Proposed Change to Comment submitted against D1.3 –

Comment - This is a resubmission of Comment #188 against D1.2-

John D'Ambrosia

Figure 1 - MPO female plug with down-angled interface and MDI active device receptacle with angled interface

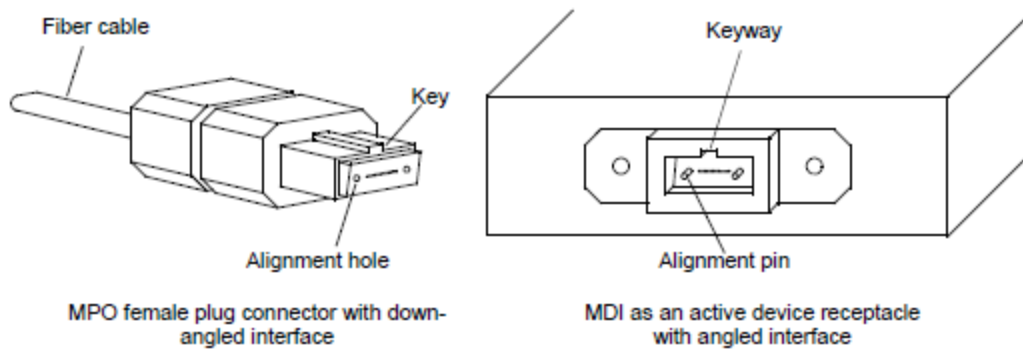
The annex is not written in an ethernet standards approach, where it addresses the breakout implementation, and doesn't address the MDI choices of the DRx / DRx-2. Additionally, Clauses 180 and 182 are making normative statements regarding the MDIs, despite the annex then providing additional MDI Connector choices.

The MDI shall meet the dimensional specifications of IEC 61754-7-1 interface 7-1-9: *MPO device receptacle, angled interface*. The plug terminating the optical fiber cabling shall meet the dimensional specifications of IEC 61754-7-1 interface 7-1-1: *MPO female plug connector, down-angled interface for 2 to 12 fibers*. The MDI shall optically mate with the plug on the optical fiber cabling. Figure 180–10 shows an MPO female plug connector with down-angled interface, and an MDI as an active device receptacle with angled interface.

The MDI shall meet the interface performance specifications of IEC 61753-021-02 for performance level D/2.
